PED Stakeholder Meeting #2 January 9, 2014

II. Background

The purpose of this public workshop is to provide citizens with a background on the Pedestrian Overlay District (PED) zoning text amendment and to gather public feedback to define and protect the character of Midtown Morehead Cherry (MMC).

Existing Regulation

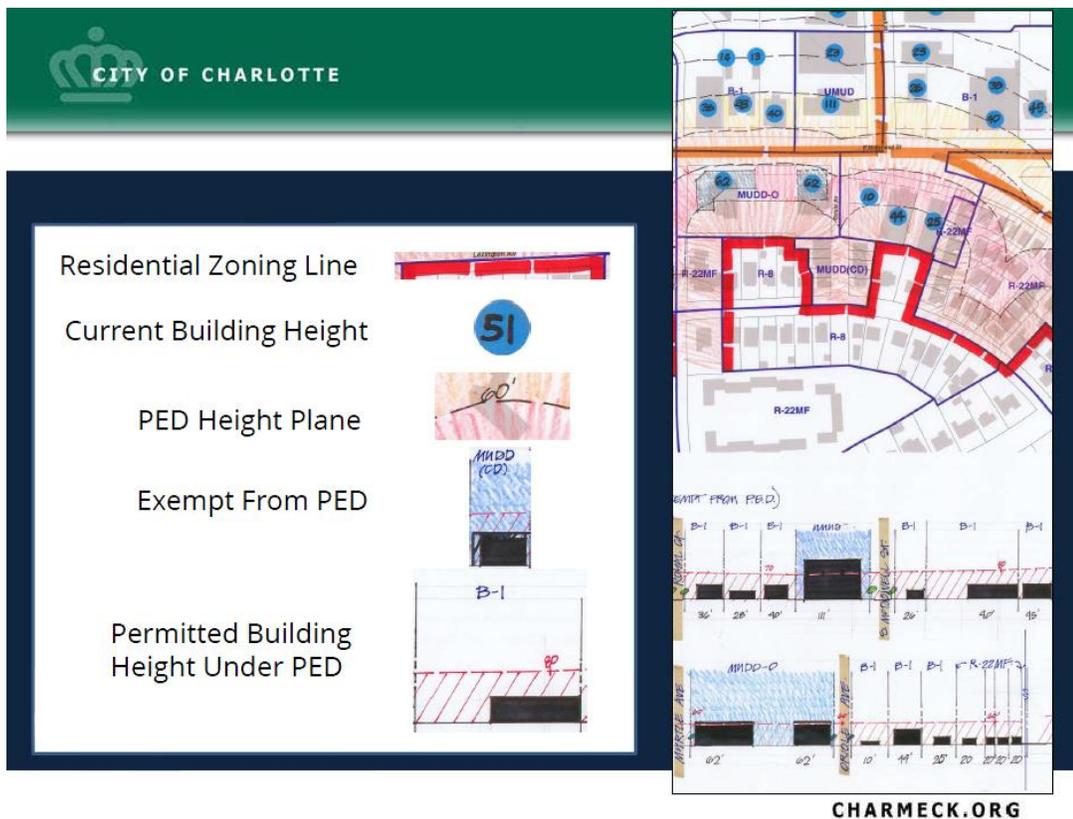
Q. Property owners are losing height of about 20' on I-277 side. Options take 10'-20' off height, depending on location.

Knocking height down is not a small issue. It takes a sizable cut at the building at the setback. The height depends on lot size, lot depth. Option A: A lot of properties do not have depth. This cut can result in a loss of 300 sq. ft. per floor.

Option C: 50' stepback then up to 100' or use height plane. With the existing tree canopy on Morehead, are you going to even see if a building is 50' or 100'? Seems like a "funny exercise."

Option C shows a measurement from Residential. But in actuality, some are closer and some further. Kent Main: The diagram shows a typical situation.

The trajectory can be misleading because individual properties have specific measurements. Our property entitles us to 80'. Actual measurements can move a property from metal to steel construction. Planning Staff: Yes, every property would have a different scenario. We can do this exercise for other properties, if you wish.

A. Michelle: 60' chosen because most buildings are 60' now. 100' are closer to South Blvd. and hospital. Already zoned and under construction.
